• **SUSPENSION—SQUEAK NOISE FROM REAR LEAF SPRINGS—REPLACEMENT REAR LEAF SPRING TIP LINER—VEHICLES PRODUCED BEFORE 10/15/01** • **NOISE—SQUEAK NOISE FROM REAR LEAF SPRINGS—REPLACEMENT REAR LEAF SPRING TIP LINER—VEHICLES PRODUCED BEFORE 10/15/01**	**Article No. 02-14-1**

FORD: 1999-2002 SUPER DUTY F-53 STRIPPED CHAS.

Figure 1 - Article 02-14-1

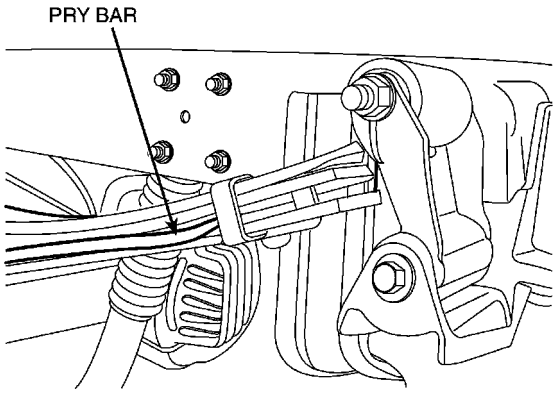
Some vehicles built before 10/15/2001 may exhibit a squeak noise from the rear leaf springs. This may be caused by the spring tip liners becoming dislodged or cracked in the spring leafs.

To service rear spring tip liners, remove load from rear suspension. To remove the spring tip liners, it is necessary to pry the leaf springs apart individually, and remove and install liners one at a time (Figure 1). After removal of original spring tip liners, install new spring tip liners service part number 2C3Z-5586-BA ensuring that the clips are firmly located in the corresponding holes.

If diagnosis leads to failed rear leaf spring tip liners, replace with 2C3Z-5586-BA as necessary. Refer to the following Service Procedure for details.
